Denison Mines (USA) Corp.
1050 17th Street, Suite 950
Denver, CO 80265
USA

Re: Cell 4A Lining System Design Report, Response to DRC Request for Additional Information – Round 6 Interrogatory, Cell 4A Design.

Subject: Revised Geosynthetic Clay Liner Hydration Demonstration
Work Plan
International Uranium (USA) Corporation
White Mesa Mill, Cell 4A
Blanding, Utah

PIPE LAYOUT PLAN

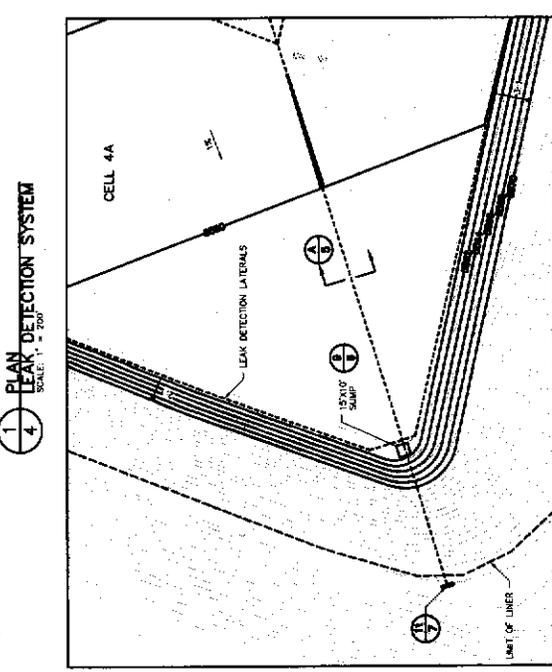
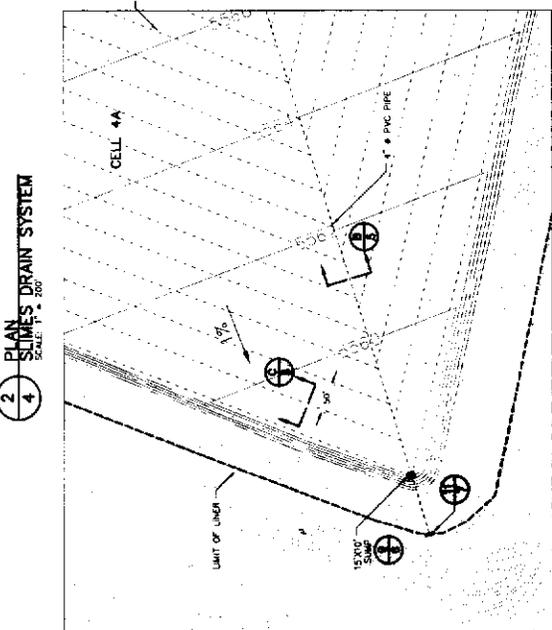
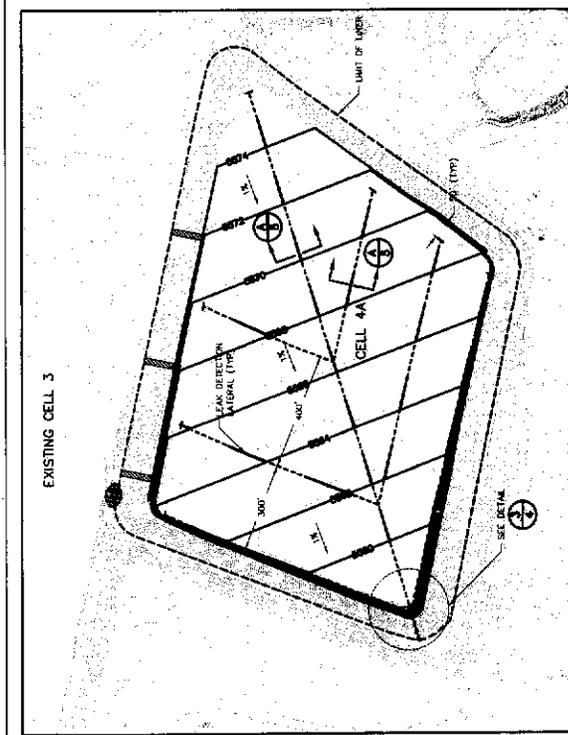
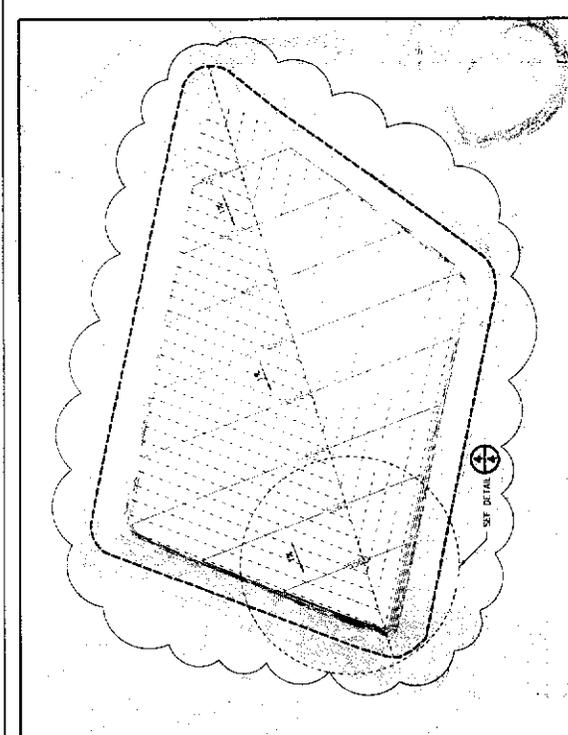
IUC must demonstrate that the slimes drain is designed to effectively and expediently remove the tailings solution remaining in the cell (after the cell has become full), using a modeling program. Programs suggested by UDEQ include SEEP/W, SVFLux, Vadose/W, HELP, UNSAT-H, HYDRUS-2D. The model should be run assuming a minimum head of solution on the upper liner and consider the following:

- *The potential tailings properties;*
- *Local environmental conditions;*
- *The potential of the coarser tailings material to clog the drain system over time.*
- *A conservative permeability of the coarser slimes material to account for permeability uncertainty; and*
- *Slope of the drain, drainpipe size and length.*

The model's analysis should provide an estimation of the maximum solution flow rate from the tailings into the slimes drain and the predicted ability of the slimes drain to remove the solution. IUC is also requested to devise a means to monitor the fluid head on the liner for a proper liner system drain and extraction system

DUSA has prepared the attached Slimes Drain Design calculation package, which provides analyses and discussions related to the design of the slimes drain system. In addition, a revised Drawing 4 of 7 is attached showing the extent of the revised slimes drainage system.
